647.1911
Job Sheet 212915

Part Name: Bracket RH

APICAL INDUSTRIES, INC.	ENGINEERING CHANGE NOTICE NO. 03811				SHEET 1 OF 1	
	DWG NO. 647.1900	REV: N/C	PREPARED BY B. PETERS	DATE: 02/13/13		EFFECT ON DWG ☐ INC. ☒ UNINC.
	DWG TITLE: BRACKETS					
	APPROVED BY: ENGR <i>[Signature]</i>	MFG <i>[Signature]</i>	QC <i>[Signature]</i>	EFF. NEXT ORDER		
TRANSACTION CODES (TC): A-ADD C-CREATE R-REVISE D-DELETE	REASON: CORRECTED DIMENSION CONFLICT & INCORPORATED ECN 03699.					ECR: 13-06

647.1911 SHOWN
647.1912 OPPOSITE

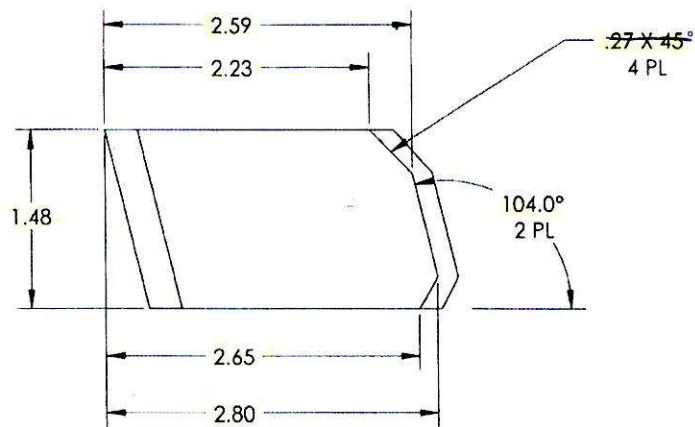
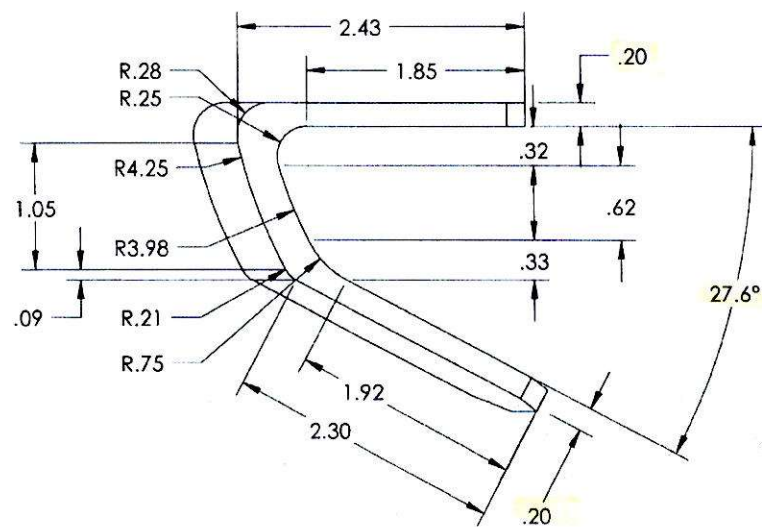
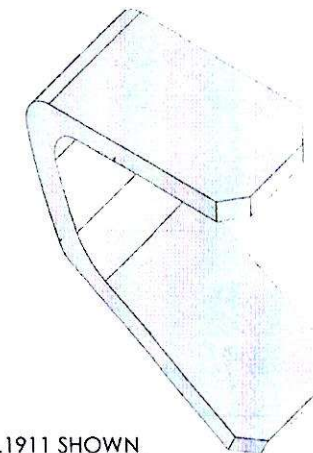
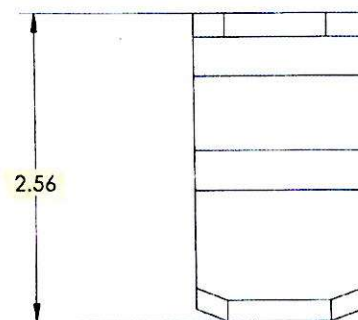
I'm contacting you about a none conformance on the extrusion that we have for 647.1911/.1912 bracket. This extrusion was purchased a wild ago for these part but we notice recently that the over-all height (2.56") is at 2.512". We have a lot of this extrusion in stock! Can you please confirm if this is acceptable.

If ever you guy's are ok with this none conformance, would it be possible to have a deviation written down so we don't have to fill out an ECR each time we produce these part.

Looking at this drawing and where the parts are used, I think this is fine. These clips are used internally on the airframe and riveted on both sides to the structure so that the rest of the CCK can be installed.

Jacob, I will leave it up to you to figure out the deviation portion of this.
